Thank you for your interest in the Avnet MicroZed System-On-Modules. Although Avnet has made every effort to ensure the highest possible quality, these kits and associated software are subject to the limitations described in this errata notification.

2 Identifying Affected Modules

3 Errata

Figure 2 – JT4 Pull-up Connected to PUDC_B, JX1_LVDS_2_P, and JX1-Pin17

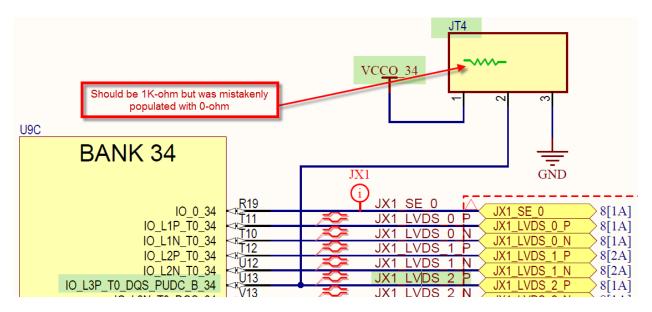
On MicroZed, the PUDC_B signal is in Bank 34 of the Zynq-7000, Pin U13 on component U9C on Sheet 6 of the schematic document. This pin is tied to schematic signal JX1_LVDS_2_P, which is also tied to resistor jumper JT4 and Micro Header JX1 Pin 17.

Resistor jumper JT4 is a 3-pad component that allows an 0402 resistor to be placed either in the 1-2 position or the 2-3 position. By default, this was supposed to be populated with a 1K-ohm resistor in the 1-2 position. Unfortunately, this was mistakenly populated with a 0-ohm resistor, thus shorting JX1_LVDS_2_P to power supply VCCO_34. This effectively disables PUDC, but it also makes this I/O unusable.

Figure 3 - JT4 on MicroZed

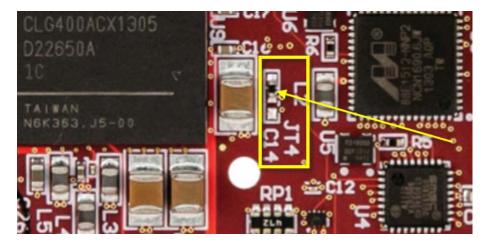
1. Remove the resistor at position 1-2 of JT4.

Solder a new, 0402 1K-ohm resistor to position 1-2 of JT4. A few suggestions are listed below.

Figure 7 - Ethernet Reset Capacitor for Proper Delay

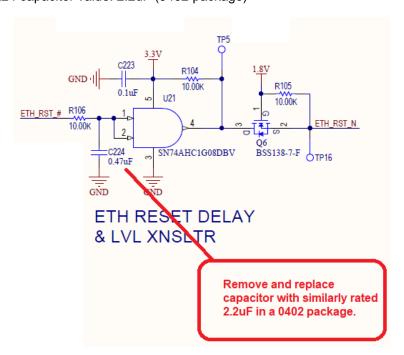
Resistor/Capacitor circuit R106/C224 of the MicroZed 7010/7020 is affected by this erratum. The resistor/capacitor values that are placed do not meet the Ethernet reset requirement of 10ms that is required by the PHY. The current time required to release the Ethernet reset is on the order of 4.7 milliseconds.

If the Ethernet reset duration significantly impacts operation in the end user application an option exist that will allow for proper operation of the Ethernet PHY. The option is to modify hardware to change the capacitor value of the resistor/capacitor combo that will allow for a time constant that is larger than the 10ms that is required by the PHY.

Recommended C224 capacitor value: 2.2uF (0402 package)

Figure 9 - Ethernet Reset Proper Voltage Level on MicroZed

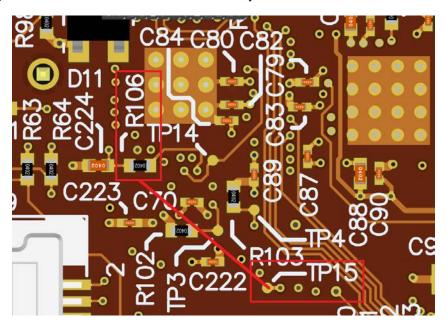
Signal ETH_RST_# of the MicroZed 7010/7020 is affected by this erratum. This signal is the output of a translation circuit from 3.3V to 1.8V and enters the ethernet reset RC delay circuit described previously. The ETH_RST_# signal is the source for the RC time delay circuit used to implement the final ethernet reset to the PHY. The VIH (high-level input voltage) for the AND GATE IC, U21, that the delayed 1.8V ETH_RST_# signal drives has a minimum voltage of 2.1V which will not be achievable by the ETH_RST_# signal. This circuit relies on the 3.3V output pullup to bring the signal to a safe 3.3V level prior to being translated to 1.8V by the FET circuit prior to the PHY.

If the Ethernet reset control impacts operation in the end user application a possible option exists that will allow for proper operation of the Ethernet PHY. The option is to modify hardware to dead bug resistor R106 to remove ETH_RST_# from the RC time delay circuit. Where the dead bug of resistor R106 occurs, signal PG_MODULE, TP15 in Figure 9 below, could be used to replace the ETH_RST_# signal which would put the proper voltage level on the ethernet reset RC time delay and translator circuits.

This workaround should not be anticipated as a permanent solution. It is recommended that users migrate to MicroZed Revision H to avoid this voltage level issue if proper operation of the Ethernet PHY is needed.

Figure 10 - QSPI Reset Resistor R69 on MicroZed

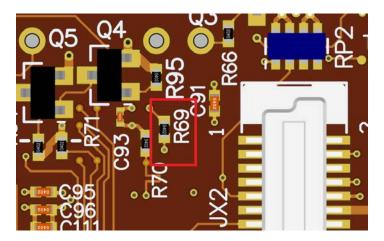
QSPI pin A4 is RST#/RFU and is currently attached through a 0-ohm resistor to signal PS_SRST#. The QSPI is operated from a 3.3V power supply and concerns have been raised that the PS_SRST# signal is a 1.8V signal.

Removing 0-ohm resistor R69 would allow the QSPI device to only use an internal pull-up resistor to control the reset of the device and eliminate the concern that a 1.8V signal was driving a 3.3V IO.

Figure 11 – OSC Enable Resistor R100 on MicroZed

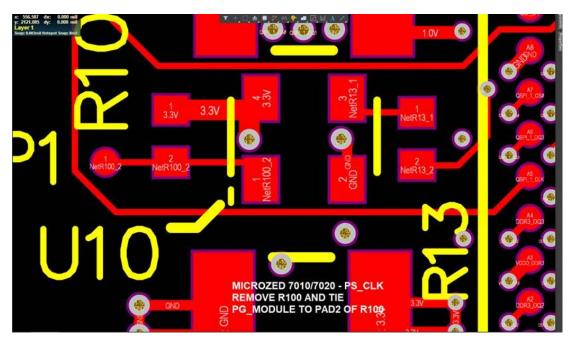
Specifically, MicroZed when operated in standalone mode fails the power off test number 4 which is a test to see if PS_POR_B is held de-asserted ($V_{\text{CCO_MIO0}}$) and the voltage ramp downs on V_{CCPINT} , V_{CCPAUX} and $V_{\text{CCO_MIO0}}$ are *monotonic* until at least one of the supplies reaches and stays below 0.40V, 0.70V and 0.90V respectively. During testing, in standalone mode, the MicroZed de-asserts and reasserts the PS_POR_B during power off and it has been shown that the PS_POR_B on reassertion occurs prior to some of the mentioned rails being below the presented levels. It has also been found that the PS_CLK signal is also still oscillating during this power off period.

If the eFuse integrity issues impacts module operation in standalone mode, possible modification options exist that will allow for proper operation resolving the issues potentially affecting eFuse integrity. The first modification is to tie PG_MODULE signal to the ENABLE pin of the PS_CLK oscillator. The second modification is to remove the TLV62130 power supplies on the module and replace with TLV62130A devices. The TLV62130A has a more robust Power Good signal which resolves the issues seen in standalone mode.

The modification to the PS_CLK oscillator is to tie PG_MODULE signal to PAD 2 of R100 (NETR100_2) in Figure 11.
